- Subject: U.S. airworthiness certification of "prematurely" exported sailplanes.
- Effectivity: DG-400 serial numbers 4-3,4-32,4-36-39,4-50,4-51,4-68,4-78,4-91,4-98,4-99,4-108,4-111-113,4-116,4-117,4-119,4-120,4-127,4-128,4-133,4-134,4-139,4-142-144,4-146-151,4-176

Ammendment to TN 826-1

Instruction for installation of the sailplane and engine identification plates required by TN 826/1.

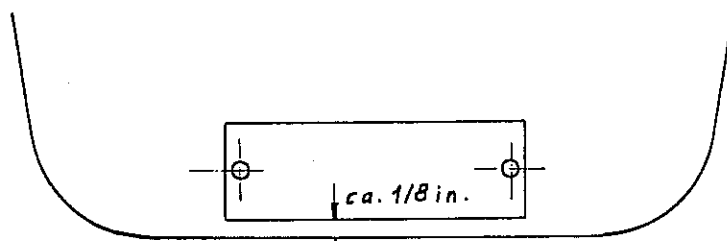
- b) engine identification plate
install the plate at the front cooling rib of the front cylinder head according to the scetch with two 1/8 in. poprivets. Use a 1/8 in. drill. Be care- ful not to drill into the next cooling rib.
